**To***Healthy Waters***From***Woods**Jasmin Moll – 3 Waters Engineer**Bidara Pathirage - Senior Associate Engineer***Reviewed***Pranil Wadan – Technical Director**W-REF: P24-646 Drury Centre – Stage 2**22 August 2025*

## Drury Metropolitan Centre Fast-track, Auckland Council Specialist Memo, Annexure 7 - Woods Response

This memorandum has been prepared by Woods on behalf of Kiwi Property in response to recommendations and comments raised by Healthy Waters regarding the Fast-track application for Consolidated Stages 1 and 2 of the Drury Centre development (**Drury Centre Project**).

Table 2: Flood assessment

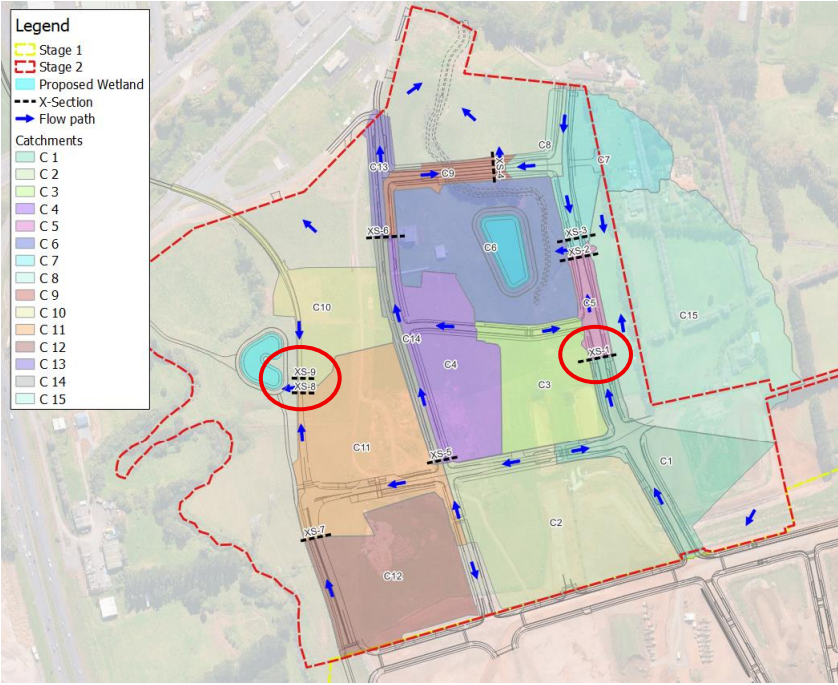
Healthy Waters Recommendation	Woods Response																					
The Applicant must provide a final copy of the hydraulic model prior to Engineering Plan Approval and prior to establishment of any impervious surfaces authorised by this consent.	Noted – however, the models have already been provided to Healthy Waters on 21/07/2025 and are not anticipated to change prior to Engineering Plan Approval submission. If necessary (e.g.: as a result of any significant changes), revised models will be provided prior to EPA submission.																					
The Applicant must provide the final proposed finished surface design that demonstrates no loss of storage volume within the Fitzgerald Stream 1% AEP floodplain.	While the proposed works will result in displacement of floodplain storage, this displacement does not generate any adverse effects within the Fitzgerald Stream 1% AEP floodplain. This was addressed in Stormwater Assessment Report, Drury Centre, Stage 2 Version 4.'. As such, while a final proposed finished surface design can be provided, it is not considered necessary that this demonstrate no loss of storage.																					
The Applicant must provide an updated Overland Flow Path Assessment to address the concerns outlined under Section 3.11. It is not considered appropriate to defer resolution of remaining concerns in this regard to Engineering Plan Approval stage as any design changes required to accommodate increased overland flows may trigger the need to vary the resource consent under Section 127 of the RMA.	<p>The Overland flow path assessment dated 14/07/2025 was submitted as part of the Section 67 responses to Auckland Council.</p> <p>The assessment incorporated the primary stormwater network as per the proposed design. The blockage assumption applies to the primary network are consistent with the requirements set out in Section 4.3.5.6 of Auckland Council's Stormwater Code of Practice (SWCoP) (Version 4, July 2025).</p> <p>A 50% blockage was assumed for pipes DN &gt; 600, and 100% blockage for pipes with DN ≤ 600.</p> <p>It is therefore unclear why these assumptions have been considered inappropriate for the purpose of the assessment, and no detail has been provided as to Healthy Waters concerns with the 14/07/2025 response.</p> <p>Despite this, further assessment was undertaken for Cross-sections 1, 8 and 9, assuming 100% blockage for all stormwater pipes (Noting this exceeds requirements of the stormwater code of practice). The results are summarised in the table below.</p>

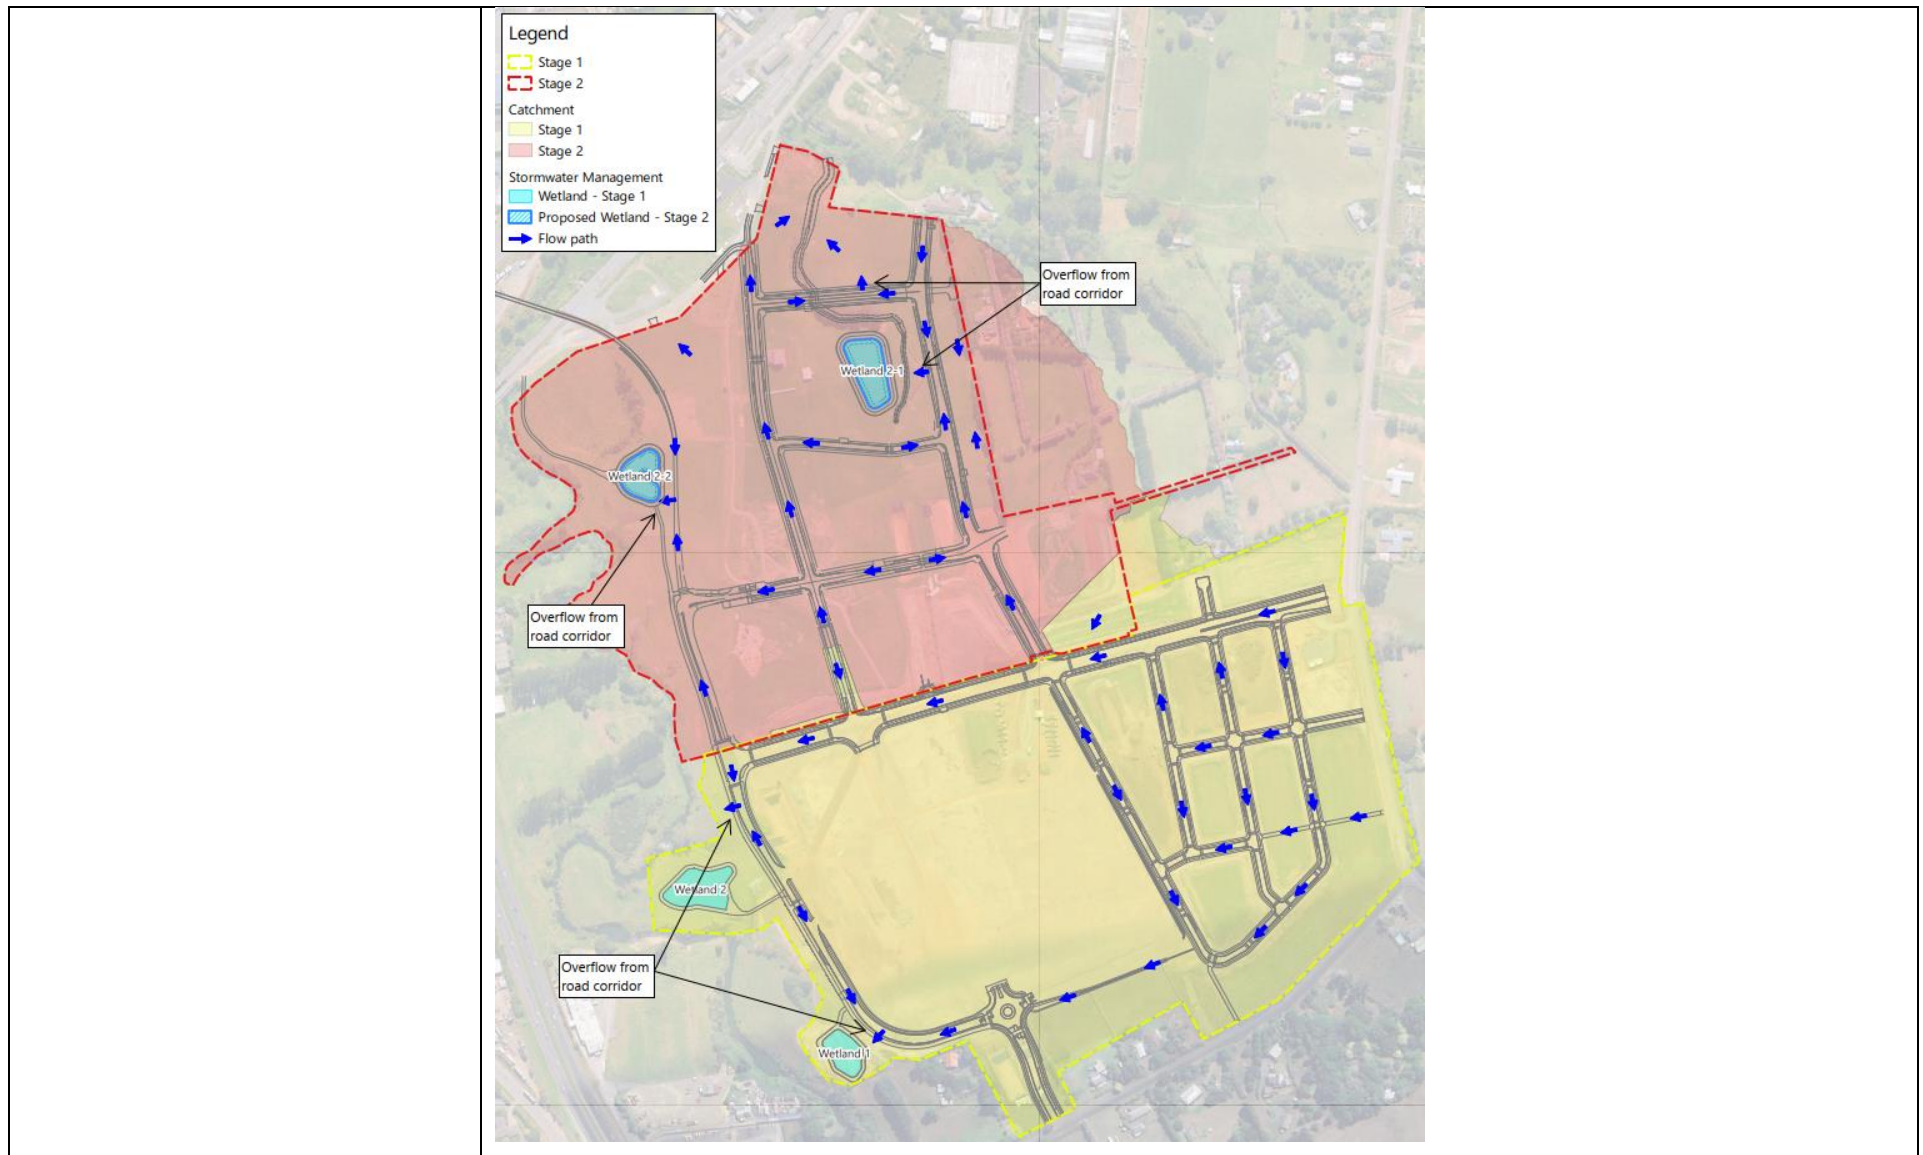
Healthy Waters Recommendation	Woods Response
	As per the proposed design no overland flows originating from Stage 1 discharge towards Stage 2. This is illustrated in Figure below that shows the intended direction of overland flows within Stages 1 and 2.

Healthy Waters Recommendation	Woods Response
	 <p>Figure 1 Fitzgerald Tributary has multiple culverts located upstream of Flanagan Road</p>

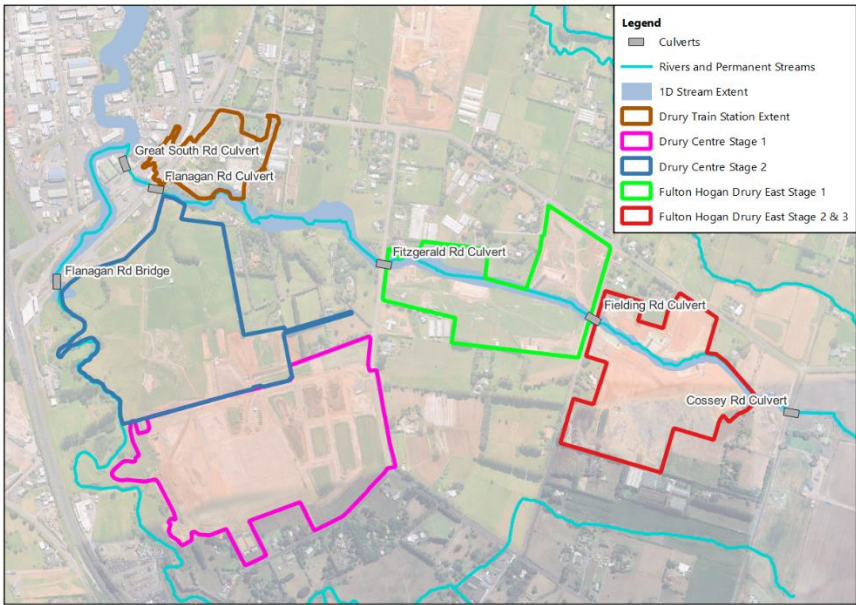
<p>The Applicant must assess the risk of flooding to proposed buildings and infrastructure adjacent to Fitzgerald stream from potential blockages of Flanagan Road culvert.</p>	<p>As described in response above, potential blockage of the Flanagan Road culvert has been considered, we have concluded that the building within Lot 40 can be safely located above the relevant flooding level at the time and a condition is proposed to this effect.</p> <p>The flood risk assessment has been carried out assuming only the Flanagan Road culvert is blocked. However, the Fitzgerald Tributary has multiple culverts located upstream of Flanagan Road as can be seen in figure 1 below.</p> <p>Any blockage assessment should consider blockage of all structures, upstream and downstream. Any blockages upstream would result in flood storage being provided upstream of the structure, resulting in lower flood levels around Flanagan Road culvert.</p> <p>Irrespective, this is to be dealt with at detail design stage (Building Consent). For the purposes of the assessment undertaken, the building has been elevated with allowances for displacement as discussed above.</p>
